ACCESSIBILITY ASSESSMENT

February 25, 2025

ADA TITLE II ASSESSMENT

Thurston Middle School
6300 Thurston Road
Springfield, OR 97478

Map for Barrier ID: AX563768

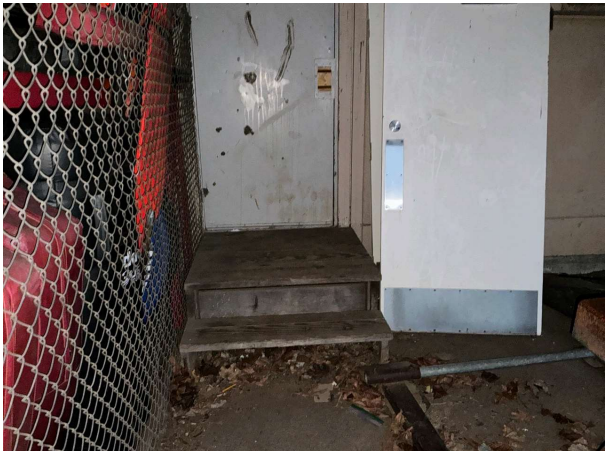
Assembly	Exterior Access Route
Type	Stairs
ADA Standard	405, 505
Barrier Detail	The ramp is required but not provided.
Location Description	Door D-7 Portable
Observed	Feb 8, 2025 by Thomas.chiarella@bureauveritas.com
Site Conditions	Access to the portable is by stair only.

Provide a compliant ramp or reduce the walking surface to maximum 1:20 (5%) running slope. The cost estimate for this barrier removal is based on providing a ramp, rather than grading the running slope to maximum 1:20 (5%). Ramp runs shall have a running slope not steeper than 1:12, and a cross slope not steeper than 1:48. [EXCEPTION: In existing sites built pre-1/26/92, buildings, and facilities, ramps shall be permitted to have running slopes steeper than 1:12 where such slopes are necessary due to space limitations. Where slopes are steeper than 1:10 but not steeper than 1:8, the rise shall be 3" maximum. Where slopes are steeper than 1:12 but not steeper than 1:10, the rise shall be 6" maximum.] The clear width of a ramp run and, where handrails are provided, the clear width between handrails shall be 36" minimum. The clear width of a ramp run and, where handrails are provided, the clear width between handrails shall be 36" minimum. [EXCEPTION: Within employee work areas, the required clear width of ramps that are a part of common use circulation paths shall be permitted to be decreased by work area equipment provided that the decrease is essential to the function of the work being performed.] Ramp runs shall have maximum 30" rise. Ramp landings shall be located at the top and bottom of ramp runs, and at turns of ramp direction. Landings shall be 1:48 maximum slope in any direction. Landings shall be minimum 60" length, and as wide as the ramp run, except ramp landings at turns which shall be minimum 60" x 60" minimum. All ramp runs with a rise of 6" or greater shall have handrails on each side of the ramp. Handrails shall be compliant. The top of the handrail gripping surface shall be 34" minimum to 38" maximum vertically above the ramp surface. Provide edge protection on the sides of each ramp run which rises more than 6" and on ramp landings. Compliant edge protection shall be provided on each side of ramp runs and at each side of ramp landings. Compliant edge protection is EITHER a curb or barrier that prevents the passage of a 4" diameter sphere where the sphere is within 4" of the ramp surface OR an extension of the ramp surface 12" minimum beyond the inner face of the rail. [EXCEPTIONS: 1. Edge protection shall not be required on ramps that are not required to have handrails and have sides. 2. Edge protection shall not be required on the sides of ramp landings serving an adjoining ramp run or stairway. 3. Edge protection shall not be required on the sides of ramp landings having a vertical drop-off of 1/2" maximum within 10" horizontally of the minimum required landing area.] Ramps and their approaches shall be designed so that water will not accumulate on walking surfaces.

Map for Barrier ID: AX563764

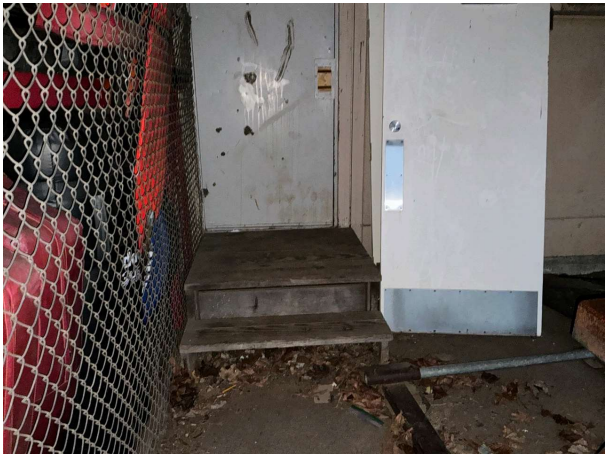
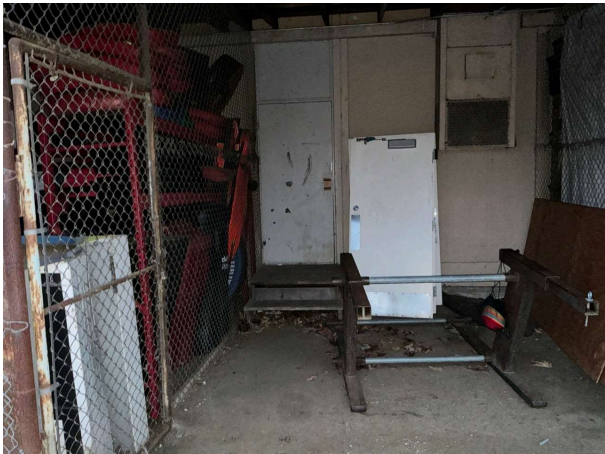
Assembly	Exterior Access Route	
Type	Stairs	
ADA Standard	504.3	
Barrier Detail	Stairs have open risers.	
Location Description	From D-7 Portable 4 (Classroom 30) to Property Line	
Observed	Feb 8, 2025 by Thomas.chiarella@bureauveritas.com	
Site Conditions	Stairs on accessible route have open risers.	
Resolution	Replace with compliant stairs that have closed risers. Open risers are not permitted.	
Quantity	Unit Cost	Total Cost
2 Riser	1,449.00	\$ 2,898
Priority	1

Photos for Barrier ID: AX563761

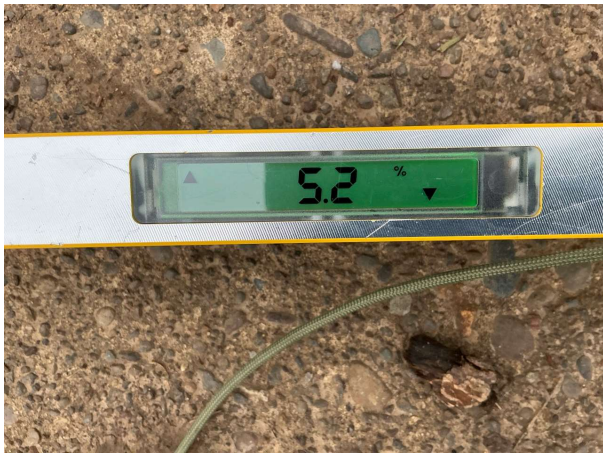
Assembly	Exterior Access Route	
Type	Exterior Accessible Route	
ADA Standard	403.3	
Barrier Detail		
The accessible route has greater than 1:20 (5%) running slope and 1:50 (2%) cross slope.		
Location Description	From Property Line to Door D-1	
Observed	Feb 8, 2025 by Thomas.chiarella@bureauveritas.com	
Site Conditions		
The exterior accessible route has cross slopes of 2.3% and running slopes of 5.2%. The non-compliant portion of the route is 6' wide, 30' in length.		
Highest Running Slope	5.2%	
Highest Cross Slope	2.3%	
Length	30'	
Width	6'	
Resolution		
The accessible route should be graded to a maximum 1:20 (5%) running slope and 1:50 (2%) cross slope. An accessible route has maximum 1:20 (5%) running slope, maximum 1:50 (2%) cross slope. [EXCEPTION: Cross slopes not greater than 1:48 (2.08%) are permitted.] Where grading to maximum running slope of 1:20 (5% running slope) is not possible, provide a compliant ramped surface within the walkway with maximum slope 1:12 (8.33%) and maximum ramp run rise of 6" without handrails. If a ramped surface with running slopes greater than 1:20 (5%) and maximum 1:12 (8.33%) rises more than 6", handrails are required. An accessible route has a minimum clear width 36". [EXCEPTION: The clear width shall be permitted to be reduced to 32" minimum for a length of 24" maximum provided that reduced width segments are separated by segments that are 48" long minimum and 36" wide minimum.] The cost estimate for this barrier removal is based on grading the running slope to maximum 1:20 (5%). The quantity and order of magnitude cost estimate provided for this barrier are limited to the extent of the area identified as non-compliant. Additional costs that may be associated with removal of the barrier are not included.

Photos for Barrier ID: AX563774

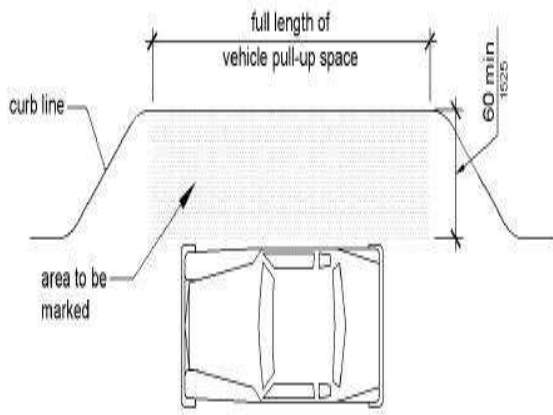
Assembly	Exterior Access Route
Type	Curb Ramp
ADA Standard	406.2
Barrier Detail	A curb ramp is not provided where the accessible route crosses a curb.
Location Description	Passenger Loading Zone
Observed	Feb 8, 2025 by Thomas.chiarella@bureauveritas.com
Site Conditions	No compliant curb ramp is present in loading/unloading zone.

Provide an accessible passenger loading/unloading zone. Passenger loading zones shall provide at least one accessible passenger loading zone in every continuous 100 linear feet of loading zone space, or fraction thereof, except bus loading areas. At least one accessible passenger loading zone shall be provided at an accessible entrance to a licensed medical care or licensed long term care facility where the period of stay exceeds 24 hours. The vehicular pull-up space shall be 96 inches wide minimum and 20 feet long minimum. The loading/unloading zone should allow the access aisle to be at the same level as the loading/unloading area it serves. The access aisle should be marked and separate from the loading/unloading area it serves. The access aisle shall be 60 inches wide minimum. Access aisles shall extend the full length of the vehicle pull-up spaces they serve. Access aisles shall be marked so as to discourage parking in them. Vehicle pull-up spaces and access aisles serving them shall comply. Access aisles shall be at the same level as the vehicle pull-up space they serve. Changes in level are not permitted. [EXCEPTION: Slopes not steeper than 1:48 (2.08%) shall be permitted.] Vehicle pull-up spaces, access aisles serving them, and a vehicular route from an entrance to the passenger loading zone, and from the passenger loading zone to a vehicular exit shall provide vertical clearance of 114 inches minimum.

Photos for Barrier ID: AX563773

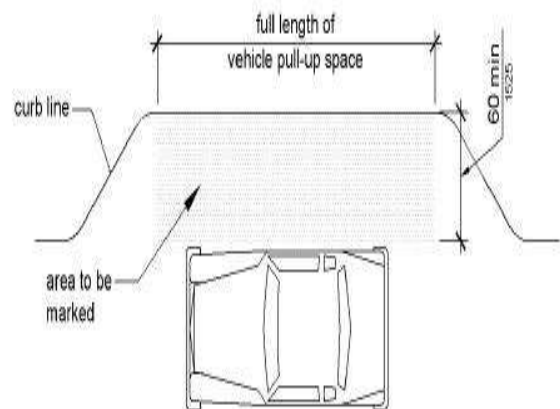
Assembly	Exterior Access Route
Type	Curb Ramp
ADA Standard	406.2
Barrier Detail	A curb ramp is not provided where the accessible route crosses a curb.
Location Description	School Bus Loading Zone
Observed	Feb 8, 2025 by Thomas.chiarella@bureauveritas.com
Site Conditions	No compliant curb ramp is present in loading zone.

Provide an accessible passenger loading/unloading zone. Passenger loading zones shall provide at least one accessible passenger loading zone in every continuous 100 linear feet of loading zone space, or fraction thereof, except bus loading areas. At least one accessible passenger loading zone shall be provided at an accessible entrance to a licensed medical care or licensed long term care facility where the period of stay exceeds 24 hours. The vehicular pull-up space shall be 96 inches wide minimum and 20 feet long minimum. The loading/unloading zone should allow the access aisle to be at the same level as the loading/unloading area it serves. The access aisle should be marked and separate from the loading/unloading area it serves. The access aisle shall be 60 inches wide minimum. Access aisles shall extend the full length of the vehicle pull-up spaces they serve. Access aisles shall be marked so as to discourage parking in them. Vehicle pull-up spaces and access aisles serving them shall comply. Access aisles shall be at the same level as the vehicle pull-up space they serve. Changes in level are not permitted. [EXCEPTION: Slopes not steeper than 1:48 (2.08%) shall be permitted.] Vehicle pull-up spaces, access aisles serving them, and a vehicular route from an entrance to the passenger loading zone, and from the passenger loading zone to a vehicular exit shall provide vertical clearance of 114 inches minimum.

Map for Barrier ID: AX563762

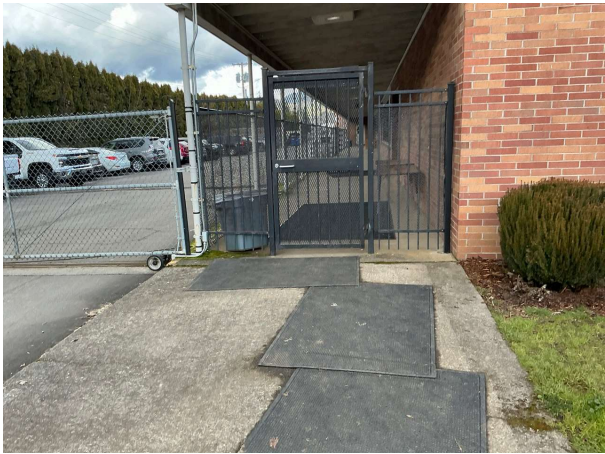
Assembly	Exterior Access Route	
Type	Gate	
ADA Standard	404.2.10	
Barrier Detail	The gate does not have a smooth surface within 10" of the ground.	
Location Description	Gate G-2 Southeast	
Observed	Feb 8, 2025 by Thomas.chiarella@bureauveritas.com	
Site Conditions	The gate does not have a smooth surface within 10" of the ground.	
Resolution	Provide a swinging gate with a smooth surface within 10" of the ground, measured vertically on the push side of the gate and extending the full width of the gate. Parts creating horizontal or vertical joints in the surfaces shall be within 1/16" of the same plane as the other. Cavities created by adding kick plates shall be capped.	
Quantity	Unit Cost	Total Cost
1 EA	276.00	\$ 276
Priority	2

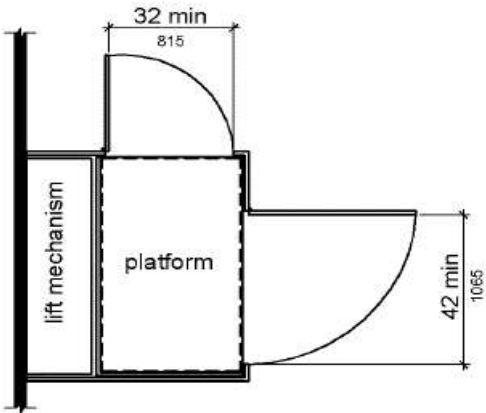
Assembly	Common Areas
Type	Platform Lift
ADA Standard	206.7, 207.2, 410;302; 303; 309; 404.3, 410.1
Barrier Detail	A platform lift is required but not provided.
Location Description	Cafetorium Stage
Observed	Feb 8, 2025 by Thomas.chiarella@bureauveritas.com

Install a platform lift. Platform lifts shall not be attendant-operated and shall provide unassisted entry and exit from the lift. Floor surfaces in platform lifts shall be firm, stable and slip resistant. Clear floor space in platform lifts shall be minimum 30" by minimum 48". Controls for platform lifts shall be within allowable reach ranges, and shall be operable without tight grasping, pinching, or twisting of the wrist. The force required to operate the controls shall not be greater than 5 lbs of force. Platform lifts shall have low-energy power-operated doors or gates. Doors shall remain open for 20 seconds minimum. End doors and gates shall provide a clear width 32" minimum. Side doors and gates shall provide a clear width 42" minimum. [EXCEPTION: Platform lifts serving two landings maximum and having doors or gates on opposite sides shall be permitted to have self-closing manual doors or gates.] If platforms are used, they shall conform with the applicable safety regulations of administrative authorizes having jurisdiction. Platform lifts shall comply with ASME A18.1 (1999 edition or 2003 edition). Platform lifts shall be permitted as a component of an accessible route in an existing building. Platform lifts can be part of the accessible means of egress where standby power is provided, and in the following situations: 1. An accessible route to a performing area and speakers' platforms in occupancies in Group A; 2. An accessible route to wheelchair spaces required to comply with the wheelchair space dispersion requirements; 3. An accessible route to spaces that are not open to the general public with an occupant load of not more than five; 4. An accessible route within a dwelling or sleeping unit; 5. An accessible route to wheelchair seating spaces located in outdoor dining terraces in A-5 occupancies where the means of egress from the dining terraces to a public way are open to the outdoors. 6. An accessible route to raised judges' benches, clerks' stations, jury boxes, witness stands and other raised or depressed areas in a court; 7. An accessible route where existing exterior site constraints make use of a ramp or elevator infeasible.

Photos for Barrier ID: AX563795

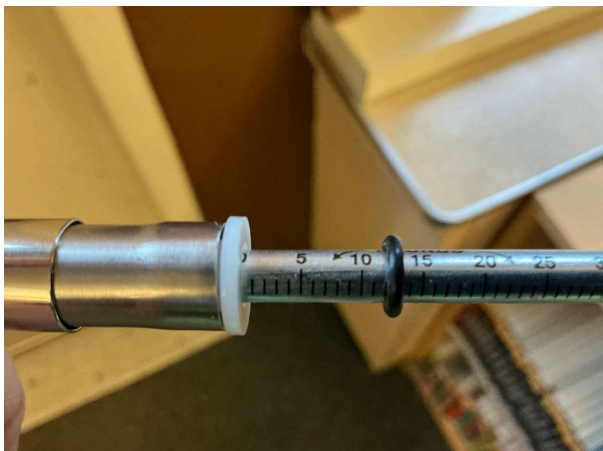
Barrier Detail

Adjust the closer or replace with an exterior door that requires no more 8.5 pounds of force for pushing or pulling the door open. The opening force of doors along an accessible route shall be as follows: 1. Exterior doors: 8.5 pounds maximum (lbf) (37.8 N). 2. Interior doors: 5 pounds maximum (lbf) (22.2 N). 3. Stairway doors at pressurized stair enclosures: 15 pounds maximum (6.8 kg) at exterior doors. 4. Where environmental conditions require greater closing pressure, power-operated doors shall be used within the accessible route. [Exception: The force required to retract latch bolts or disengage other devices that hold the door or gate in a closed position shall not apply to panic hardware, delayed egress devices or fire-rated hardware.]

Photos for Barrier ID: AX563783

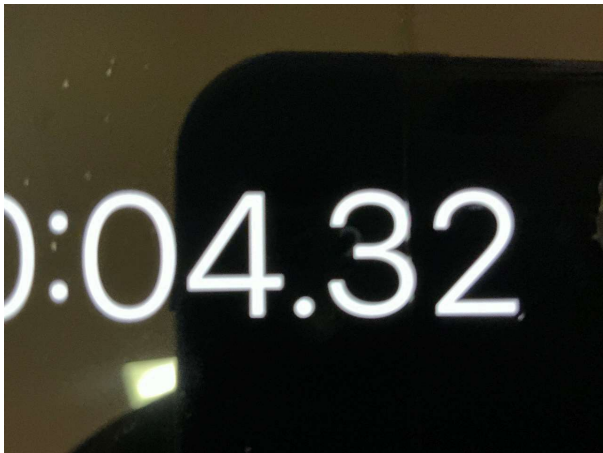
Barrier Detail

Adjust closer or remove and replace closer to ensure that the door has a closure time of at least 5 seconds within 12 degrees of the latch. Door closers and gate closers shall be adjusted so that from an open position of 90 degrees, the time required to move the door to a position of 12 degrees from the latch is 5 seconds minimum.

Photos for Barrier ID: AX563796

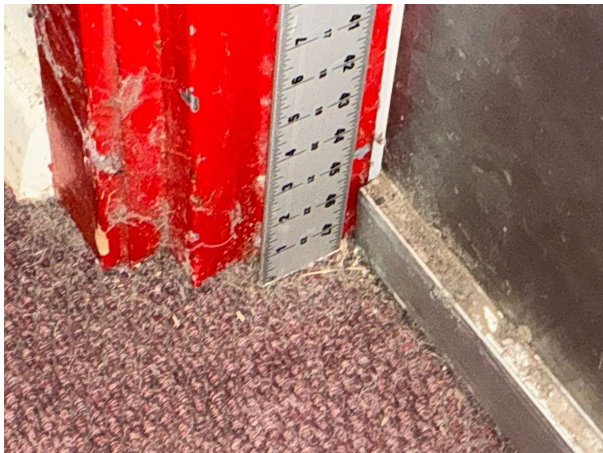
Assembly	Entrance to Building	
Type	Building Entrance - Door	
ADA Standard	404.2.10	
Barrier Detail		
The swinging door does not have a smooth surface within 10" of the ground measured vertically on the push side extending the full width of the door.		
Location Description	Door D-1 Main Entrance	
Observed	Feb 8, 2025 by Thomas.chiarella@bureauveritas.com	
Site Conditions		
The swinging doors do not have a smooth surface within 10" of the ground measured vertically on the push side extending the full width of the all 4 doors.		
Resolution		
Provide a swinging door with a smooth surface within 10" of the finish floor or ground measured vertically on the push side extending the full width of the door. Parts creating horizontal or vertical joints in the surfaces shall be within 1/16" of the same plane as the other. Cavities created by adding kick plates shall be capped.		
Quantity	Unit Cost	Total Cost
4 EA	345.00	\$ 1,380

Photos for Barrier ID: AX563789

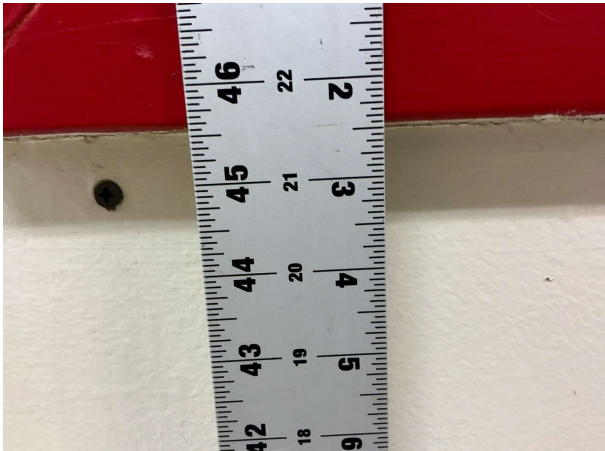
Barrier Detail

Remove and lower the mirror to a compliant height. Where mirrors are provided, at least one shall comply. Mirrors located above lavatories or countertops shall be installed with the bottom edge of the reflecting surface 40" maximum above the finish floor or ground. Mirrors not located above lavatories or countertops shall be installed with the bottom edge of the reflecting surface 35" maximum above the finish floor or ground. [ADVISORY: A single full-length mirror can accommodate a greater number of people, including children. In order for mirrors to be usable by people who are ambulatory and people who use wheelchairs, the top edge of mirrors should be 74" minimum from the floor or ground.]

Photos for Barrier ID: AX563784

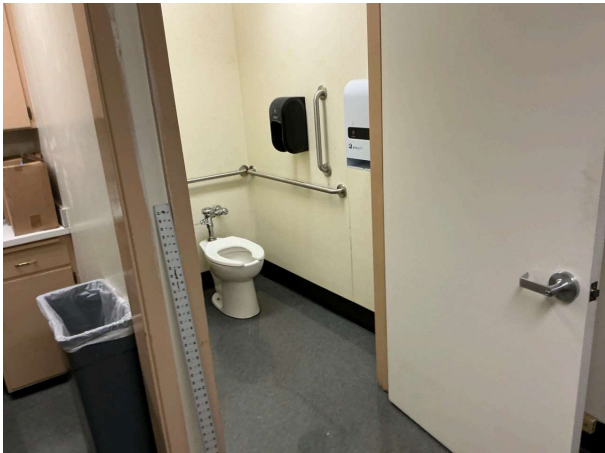
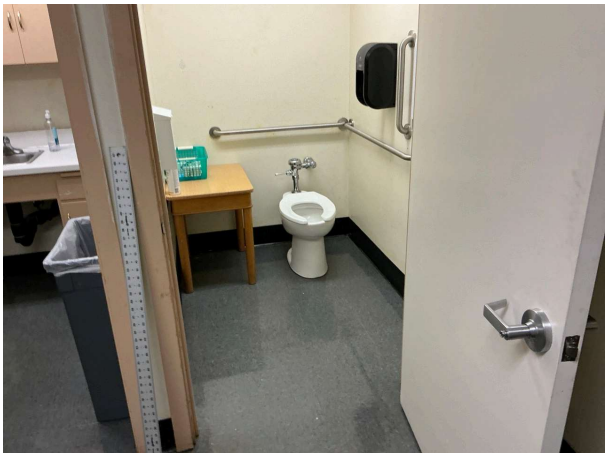
Assembly	Restroom
Type	Restroom/Bathroom
ADA Standard	603, 604, 606
Barrier Detail	The entire restroom is not compliant due to limited room dimensions.
Location Description	Unisex Restroom at Isolation Room
Observed	Feb 8, 2025 by Thomas.chiarella@bureauveritas.com
Site Conditions	The restroom has a clear width of 52".
Length	72"
Width	52"

Photos for Barrier ID: AX563809

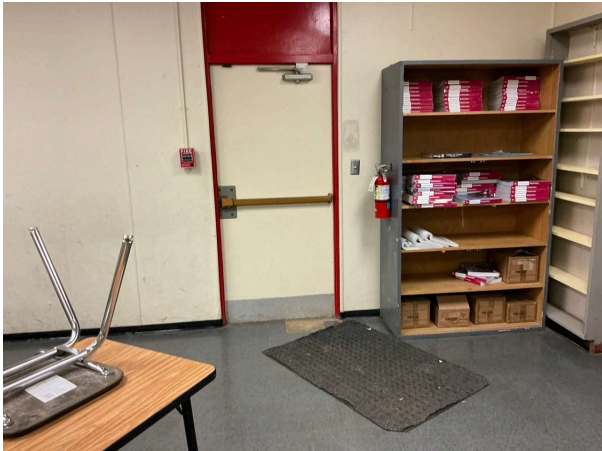
Barrier Detail

Adjust the closer or replace with an exterior door that requires no more 8.5 pounds of force for pushing or pulling the door open. The opening force of doors along an accessible route shall be as follows: 1. Exterior doors: 8.5 pounds maximum (lbf) (37.8 N). 2. Interior doors: 5 pounds maximum (lbf) (22.2 N). 3. Stairway doors at pressurized stair enclosures: 15 pounds maximum (6.8 kg) at exterior doors. 4. Where environmental conditions require greater closing pressure, power-operated doors shall be used within the accessible route. [Exception: The force required to retract latch bolts or disengage other devices that hold the door or gate in a closed position shall not apply to panic hardware, delayed egress devices or fire-rated hardware.]
